RELAYS (NONWIRE SPRING-TYPE), 197-TYPE SWITCHES, AND KS-13835 (AMA) READER—HAVING UNUSUAL CONTACT CONDITIONS REPLACEMENT CONTACTS

1.02 This section is reissued to revise 1.04 and to add new Fig. 1.

Fig. 1—Dome-Shaped Contact Mating With a Bar Contact

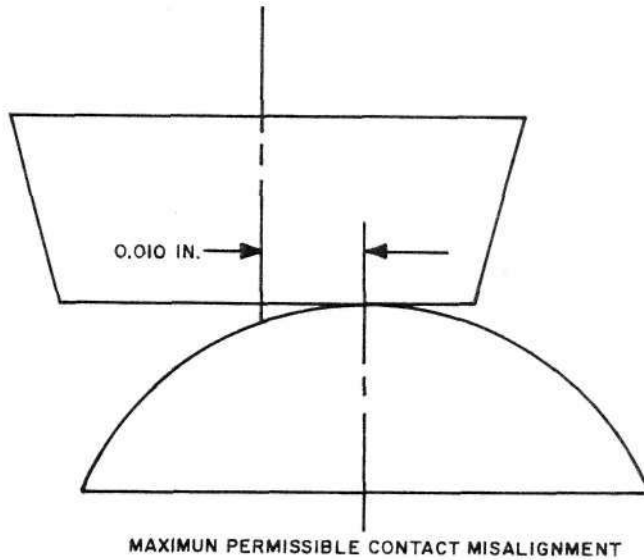
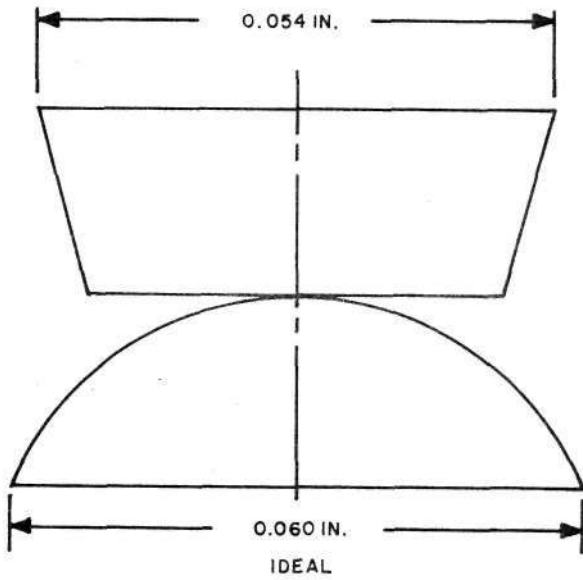
1.04 On step-by-step relays and 197-type switch vertical-off-normal (VON) springs with dome-shaped contacts, it will be satisfactory to replace only one contact of a pair leaving a dome contact mating with a bar contact providing satisfactory alignment is obtained. In this case, the dome must lie wholly within the length of the

bar and the center line of the dome must be within 0.010 inch of the center line through the width of the bar as gauged by eye. (See Fig. 1.)
